RE: **Grants Reclamation Project – DP-200 Renewal – Response to September 12, 2000 NMED Letter Transmitting Comments / Questions on Renewal Application**

**HOMESTAKE MINING COMPANY
Grants Reclamation Project
DP-200 Renewal**

**RESPONSES TO
NEW MEXICO ENVIRONMENT DEPARTMENT
REGARDING QUESTIONS / COMMENTS ON DP-200
RENEWAL APPLICATION
PER
NMED LETTER DATED SEPTEMBER 12, 2000**

FIGURE 25. CHLORIDE CONCENTRATIONS FOR WELLS D1, X, S4, F, FB AND GH.

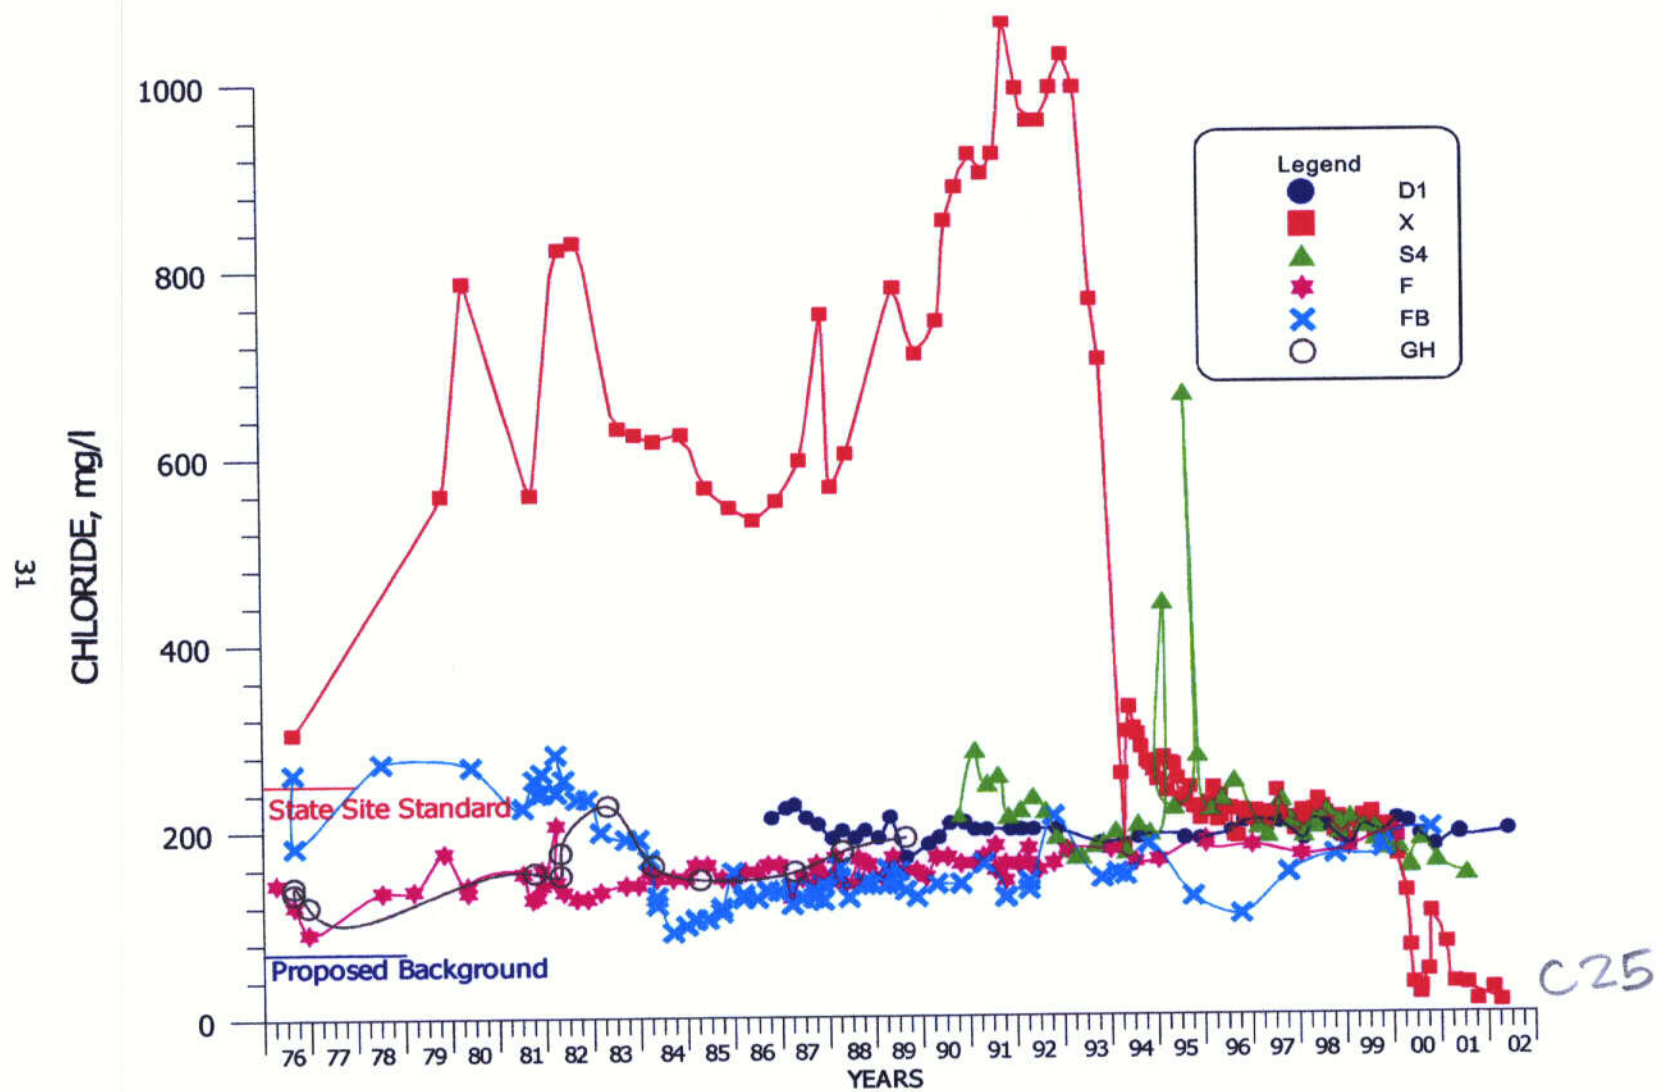
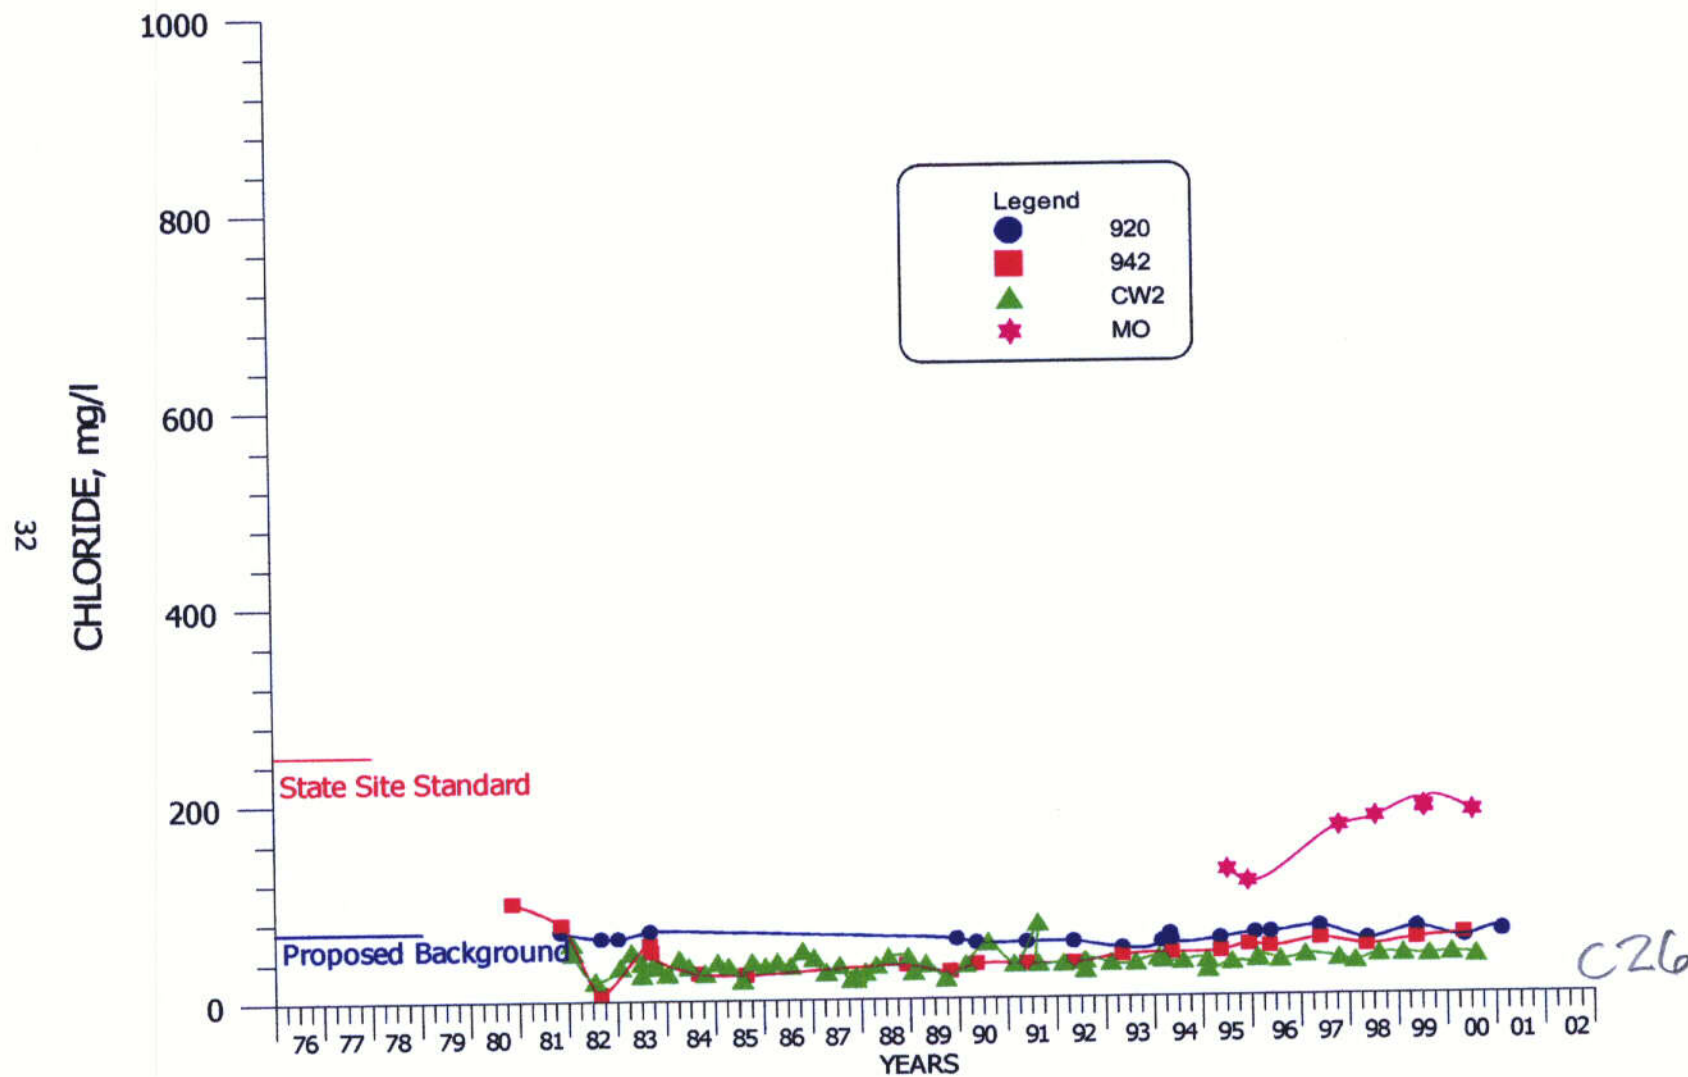
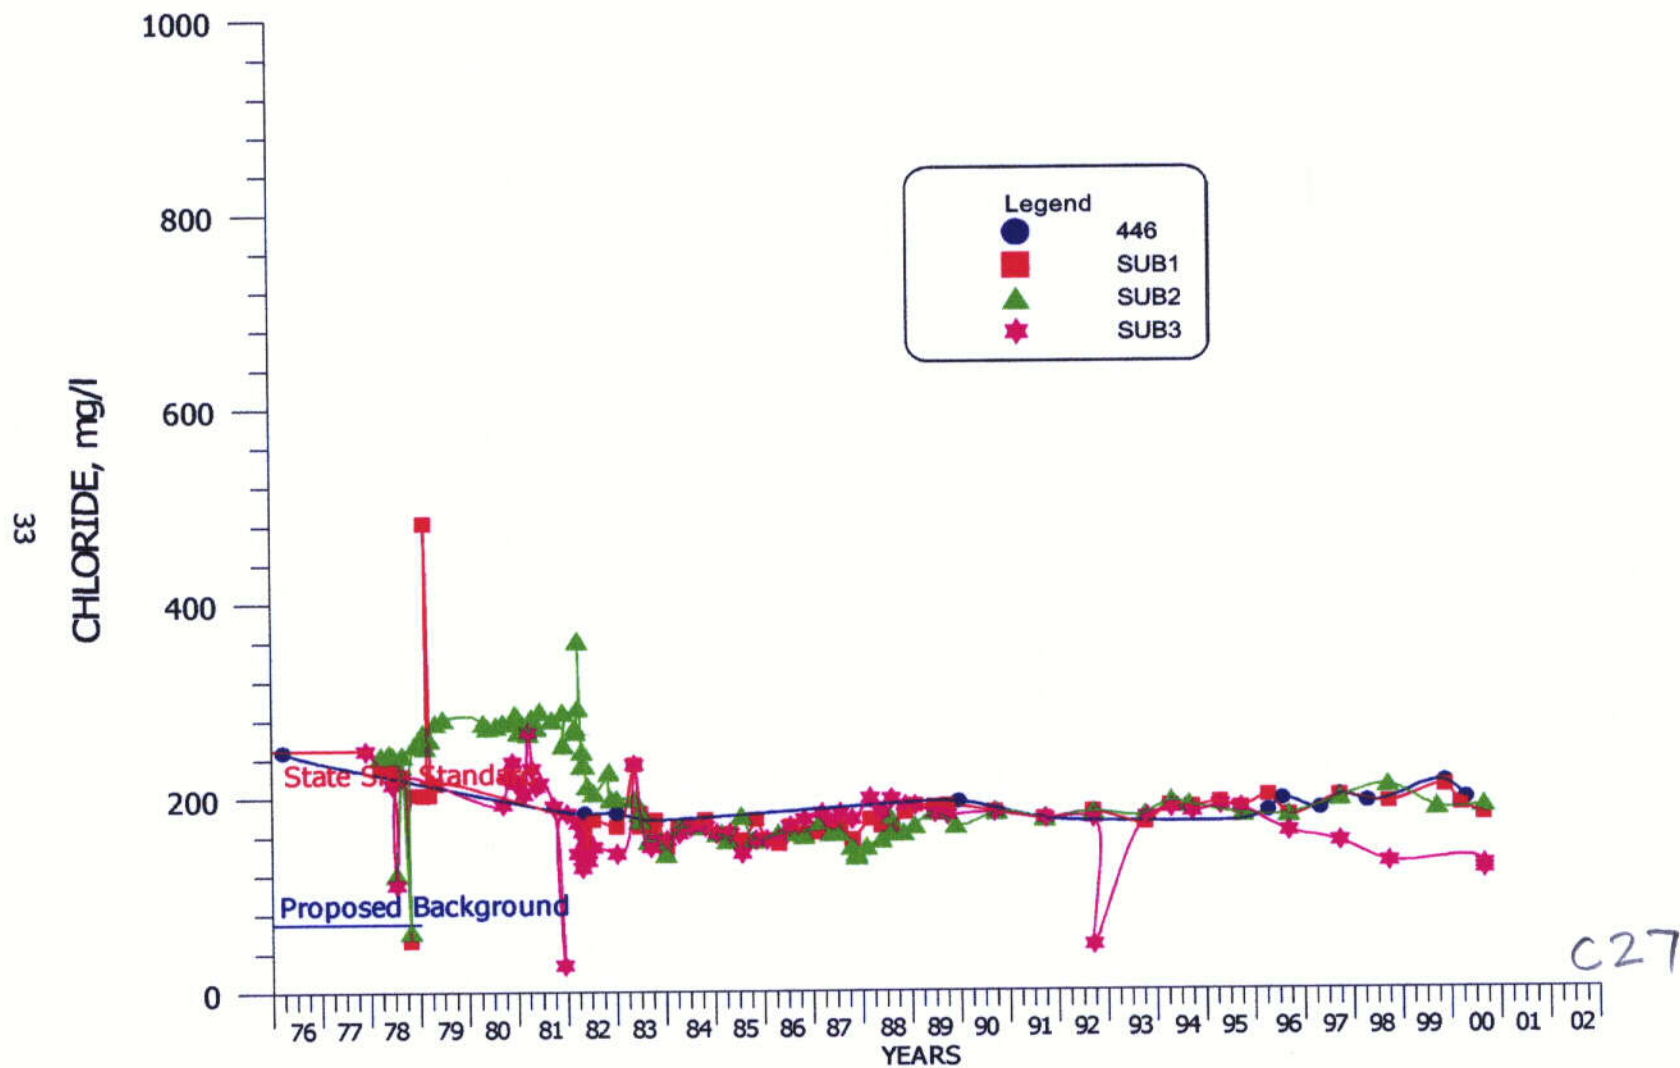
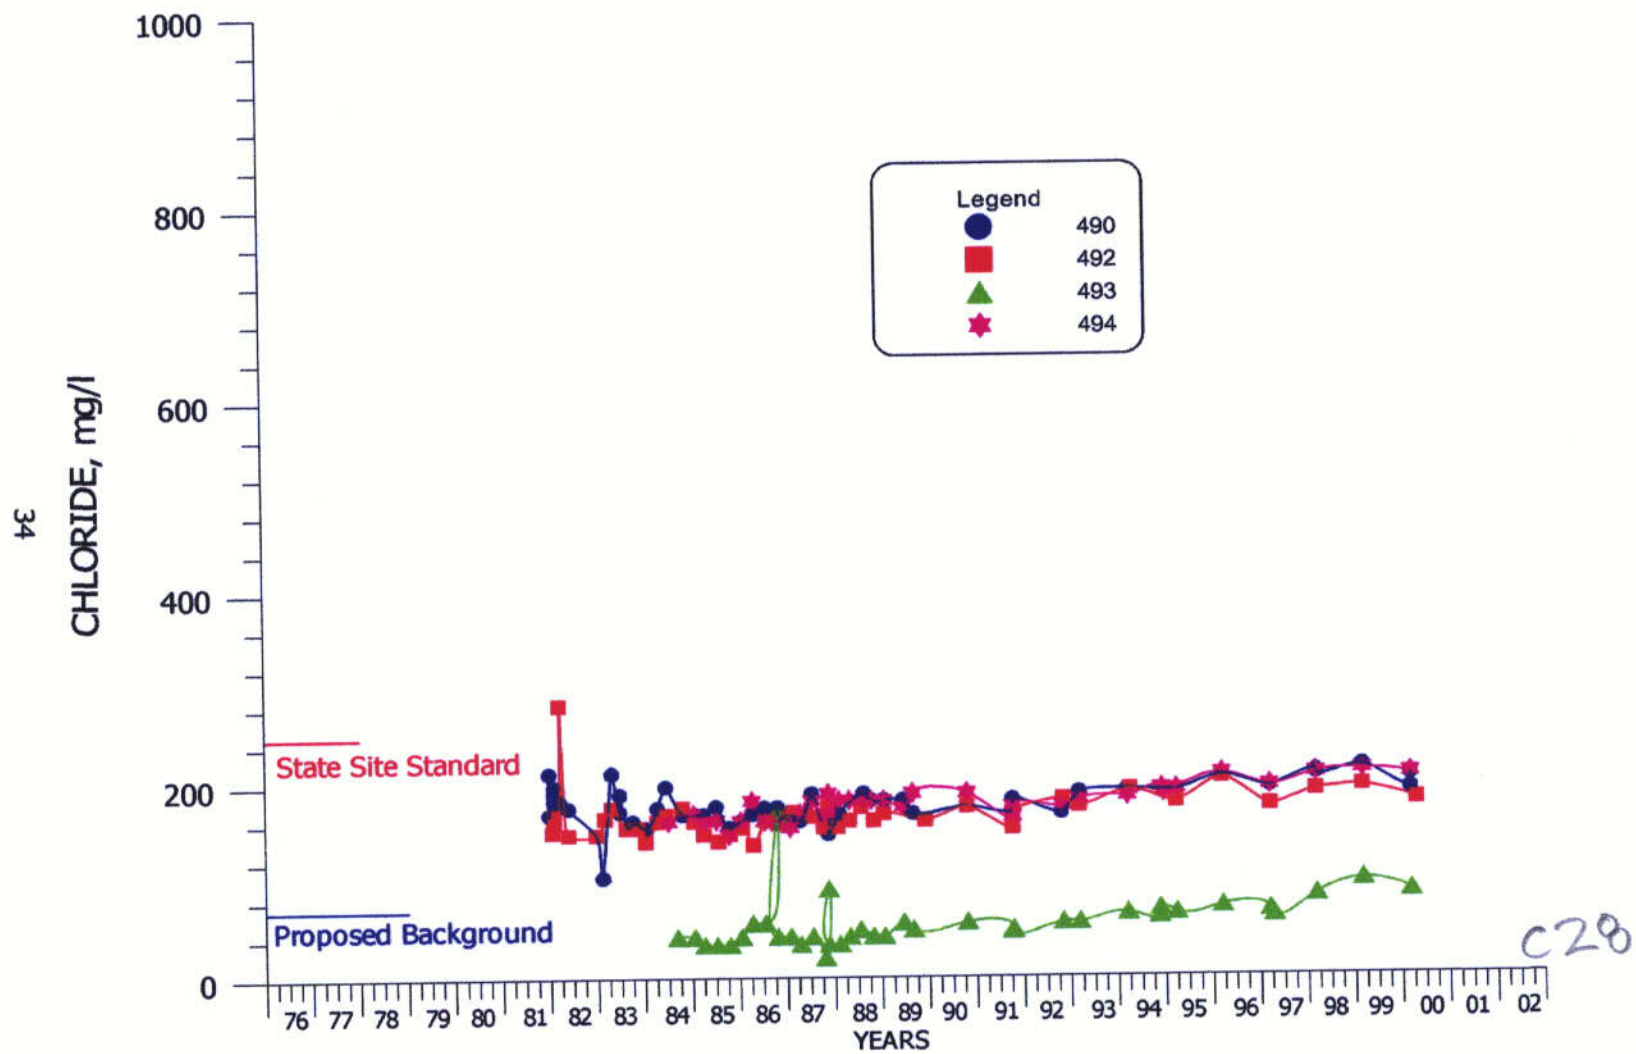
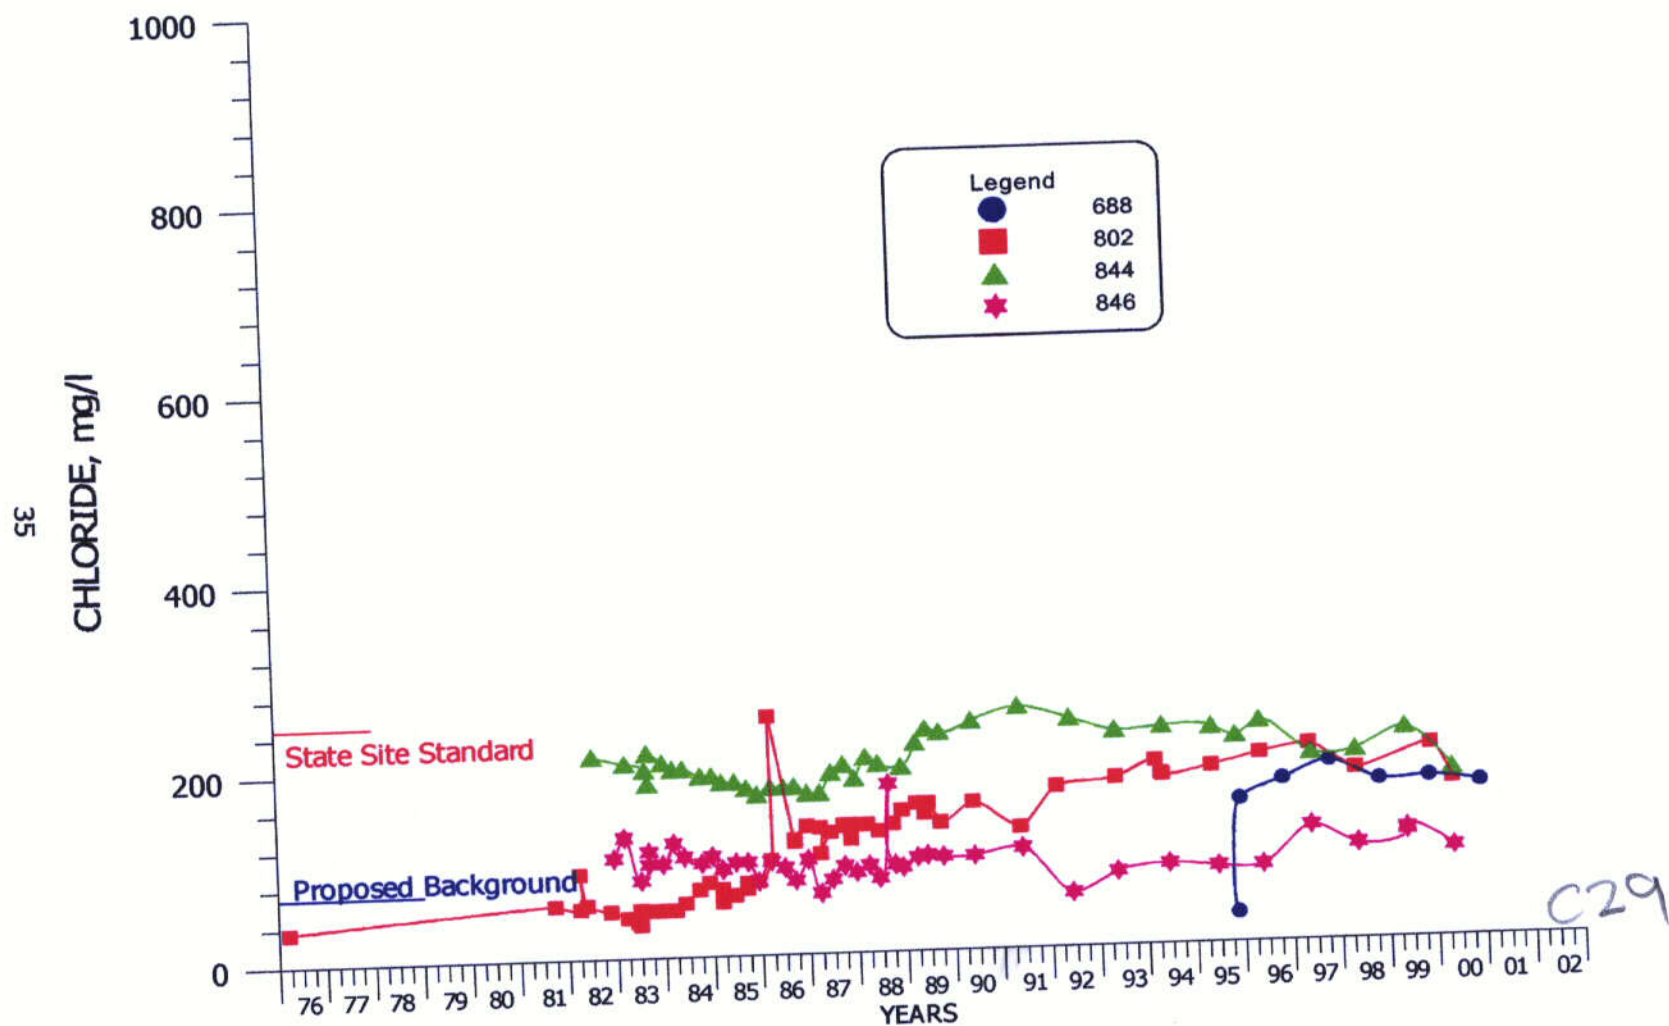
Comment: III.1.B. Graphs of Water-quality Data for the Table 2 Wells

Response: Plots for the routine monitoring wells from Table 2 of the NRC license are presented for sulfate, TDS, chloride, uranium, selenium, molybdenum and nitrate concentrations as Figures 15 through 49. The first group of wells for each of these constituents are presented for the three POC wells (Wells D1, X and S4) and

the initial figure also includes on site wells (Wells F, FB and GH). The following tabulation lists the figure numbers for each of the constituents:

CONSTITUENT	FIGURE NUMBER
SO4	15 – 19
TDS	20 – 24
Cl	25 – 29
U	30 – 34
Se	35 – 39
Mo	40 – 44
NO3	45 – 49

A few different vertical scales were required due to the large variations in parameter concentrations. The present State standard and the proposed background concentrations are presented on the plots.
